Re: **Application for Planning Permit No. 1033/2018**  
Address: **472-474 St Kilda Road, MELBOURNE VIC 3004**

# PLANNING PERMIT

472-474 ST KILDA ROAD, MELBOURNE VIC 3004

Construct a multi-storey mixed use building, comprising a retail, food and drinks premises, bar, serviced apartments and dwellings, a reduction in the number of car parking spaces required and a licence for the sale and consumption of liquor.

1 GYM PLAN - LEVEL ONE  
ASK-042 SCALE 1 : 200

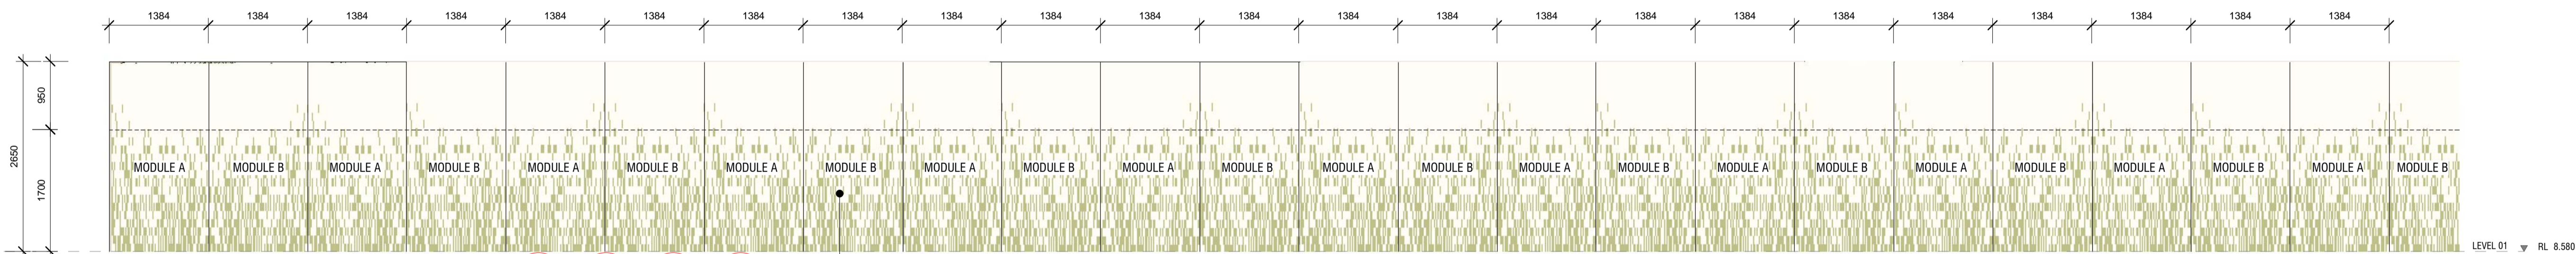
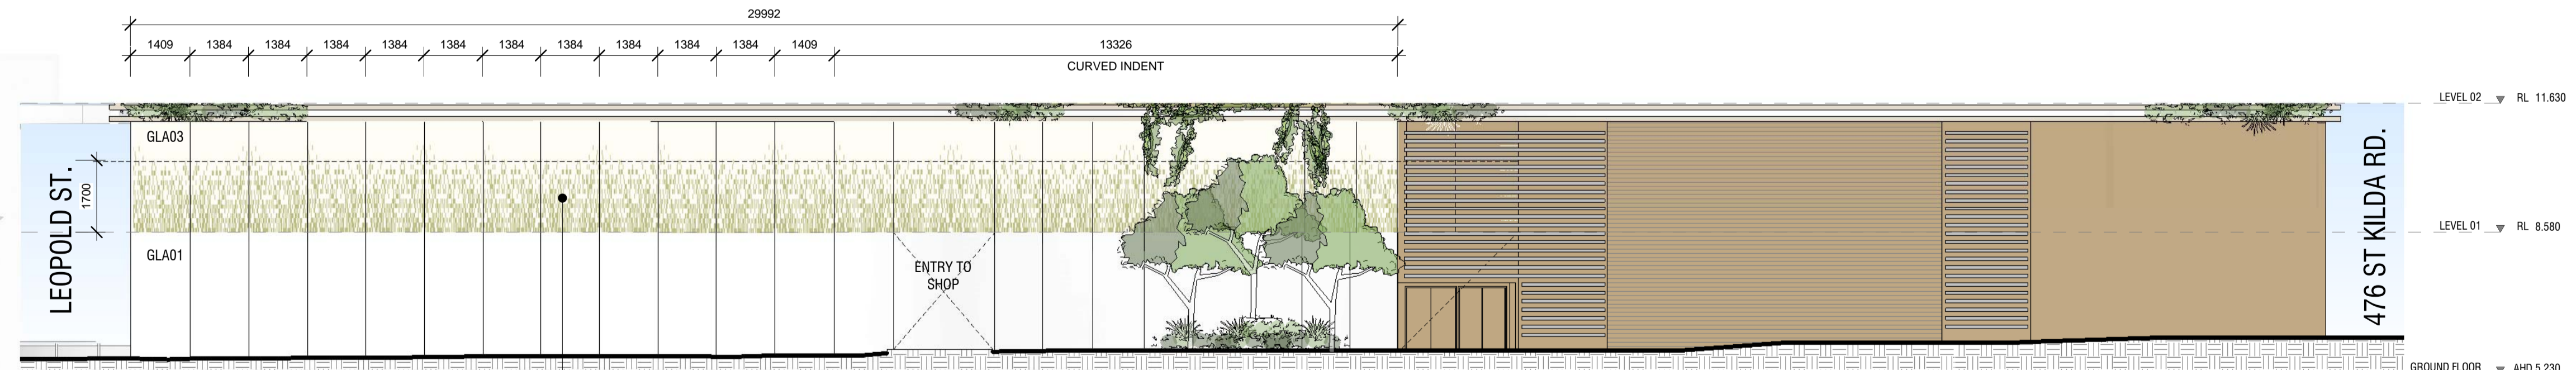
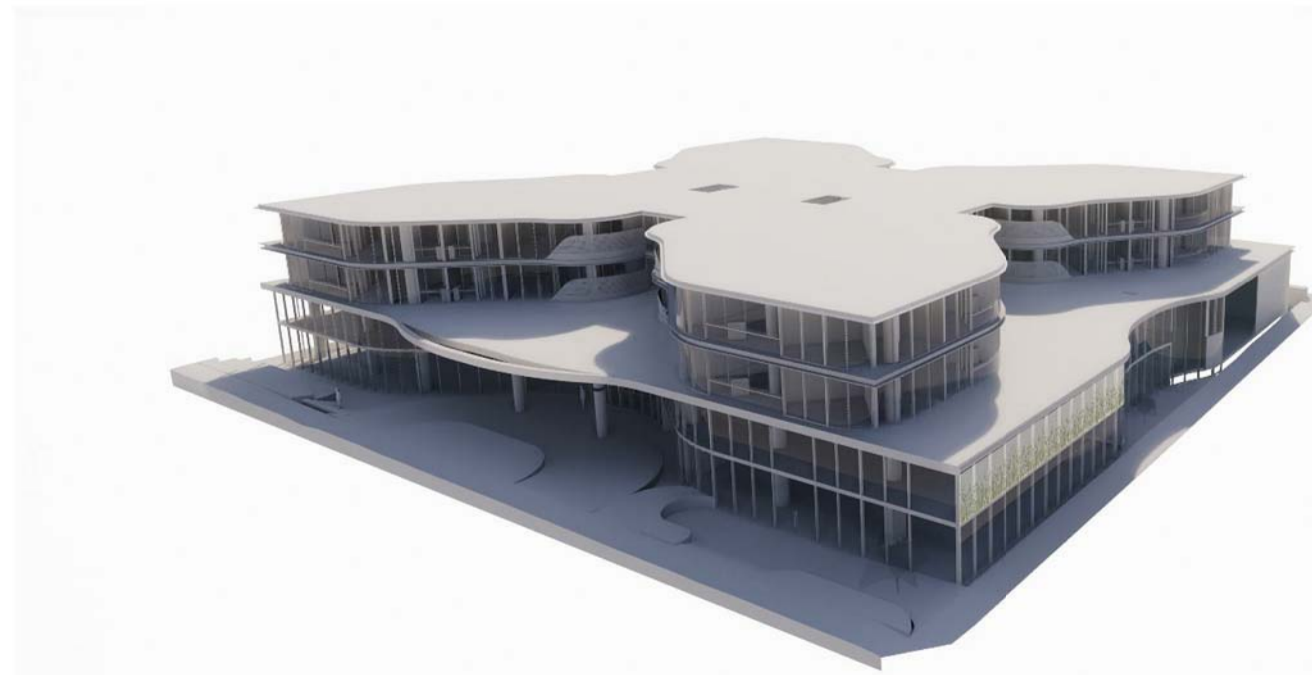
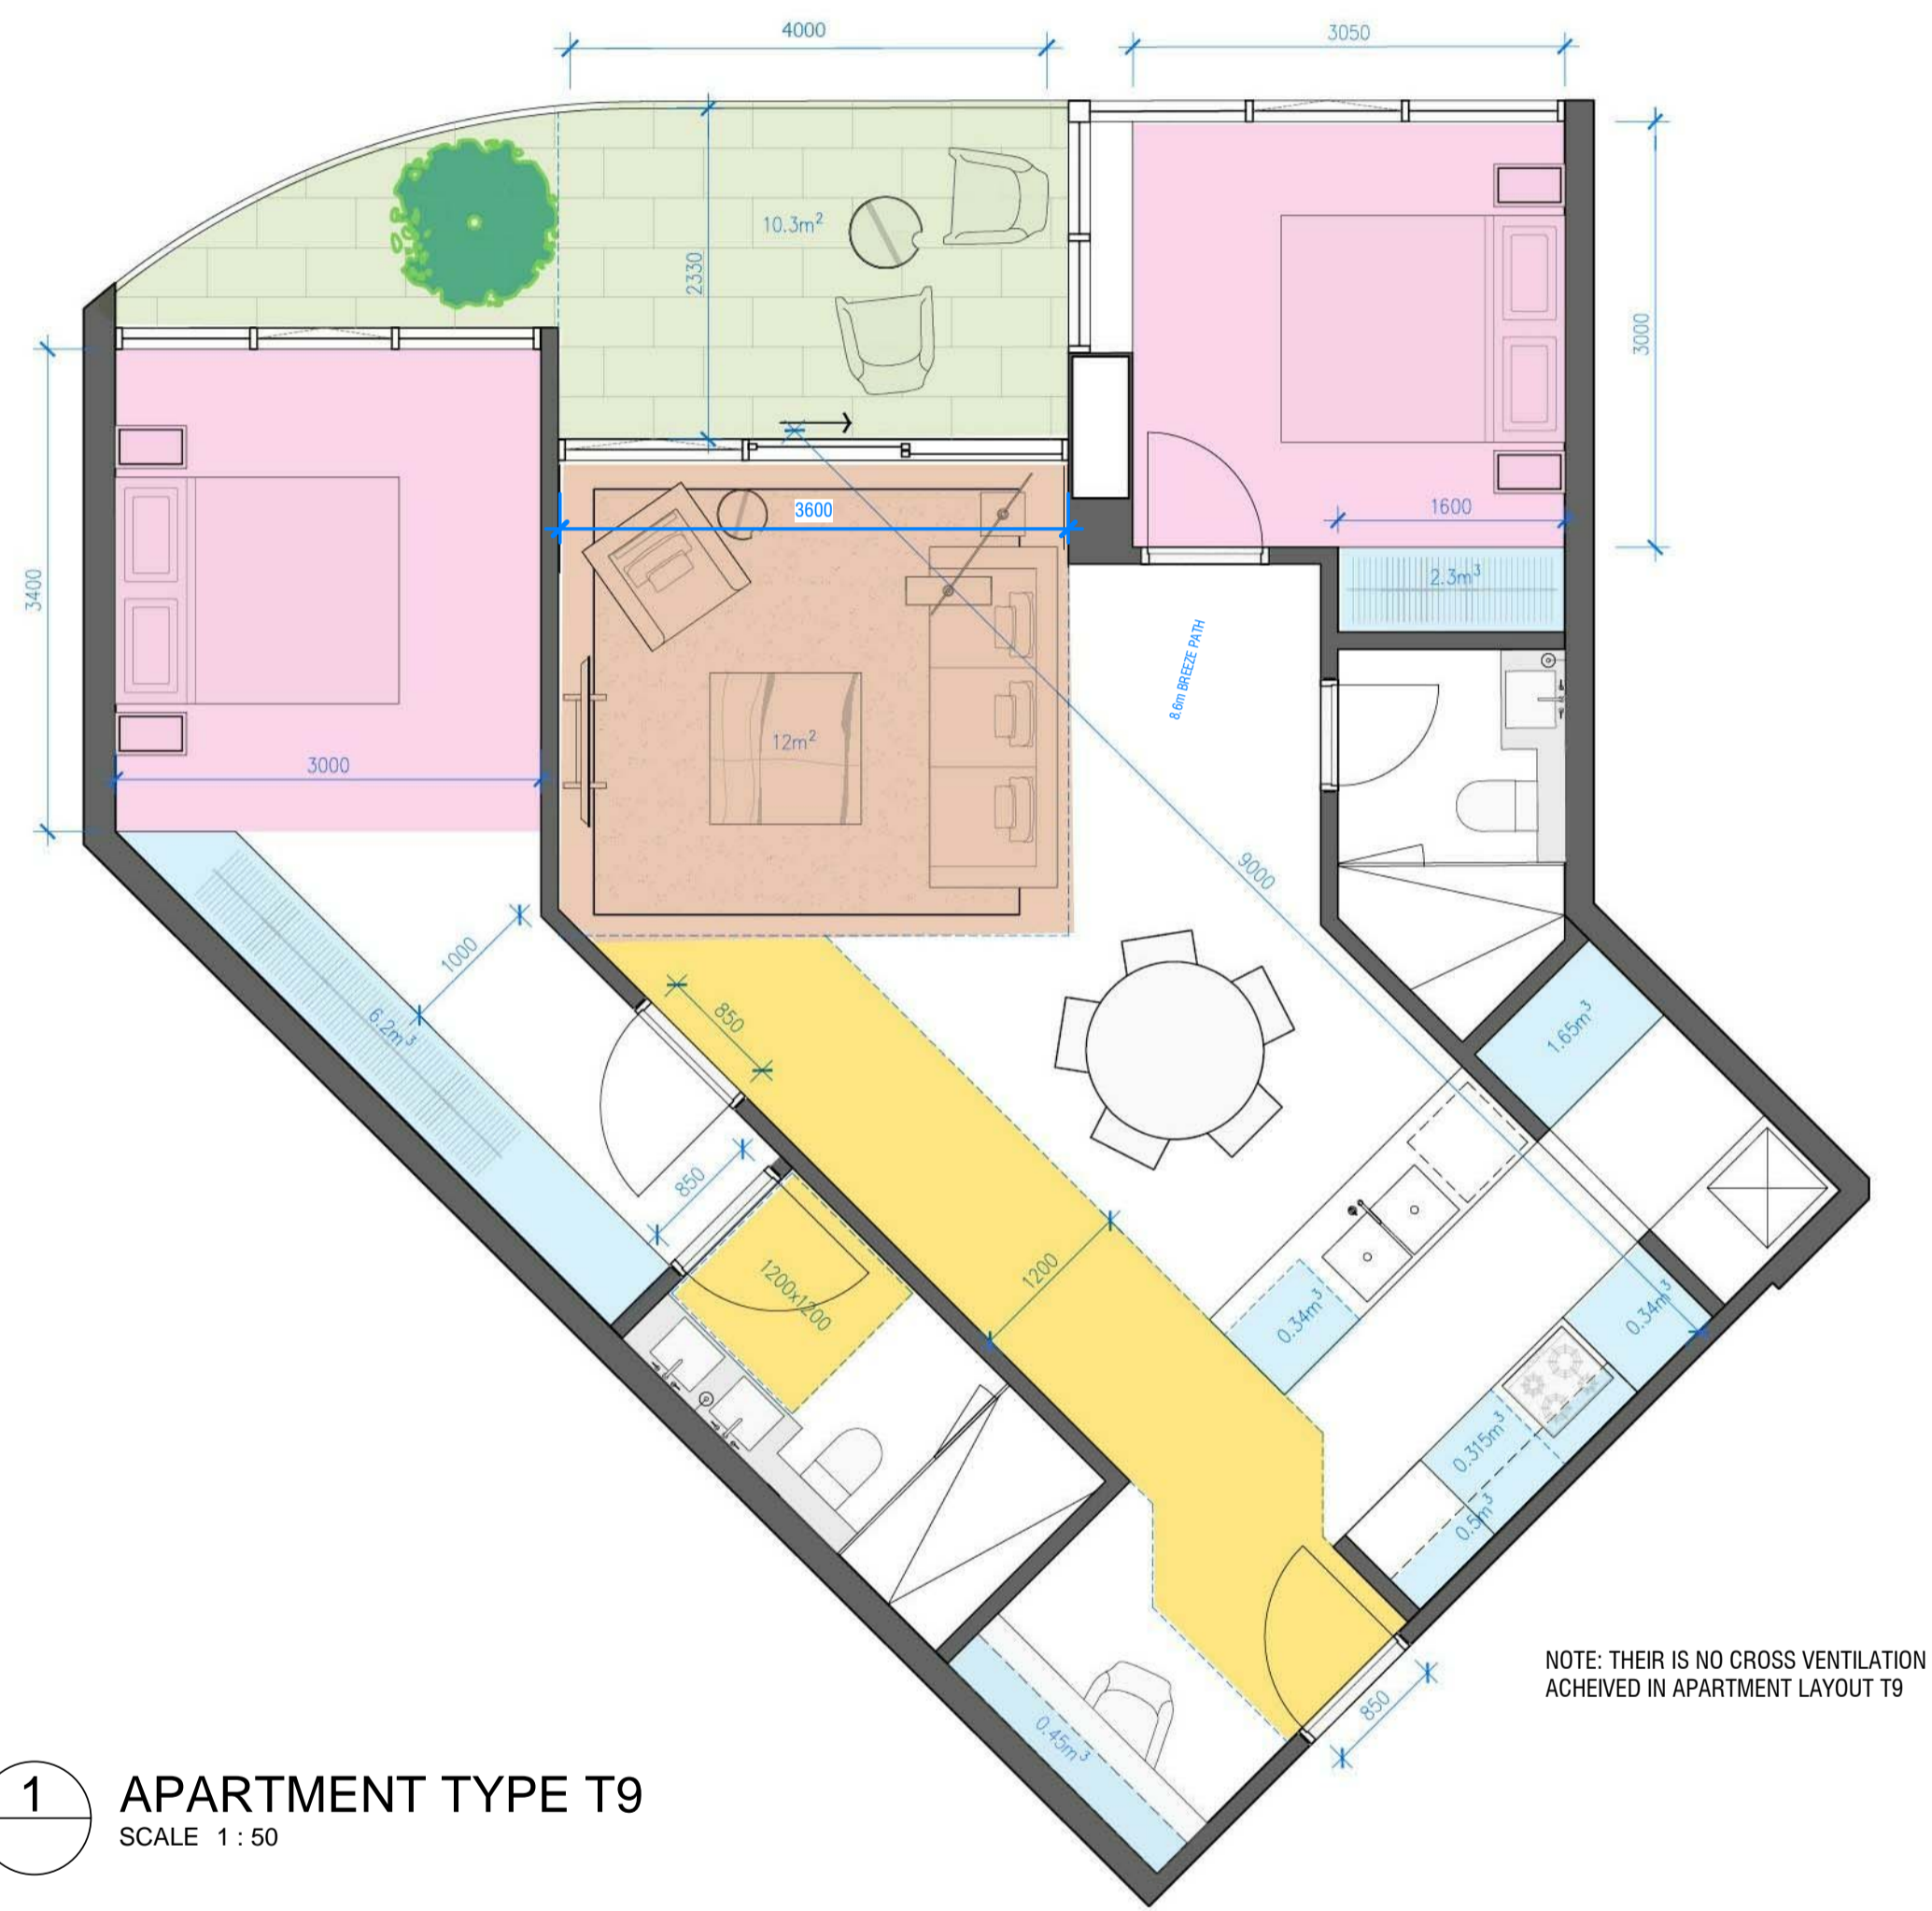
- (f) Details of privacy measures to limit views from the western glazing to the gym at the first floor (marked 'amenity' on plan TP 21-001 dated 17 October 2019) in a westerly direction below 1.7m.

RFI - CONDITION 1(f) - PRIVACY MEASURES TP LIMIT VIEWS FROM WESTERN GLAZING IN THE GYM

INDICATIVE ONLY - ARCHITECTURALLY DESIGNED PRIVACY MEASURES TO EXTENT OF AMENITIES TO LIMIT VIEWS INTO ADJACENT PROPERTIES. CUSTOM FRIT TO 1700MM HIGH TO ACHIEVE 50% VISUAL PERMIABILITY
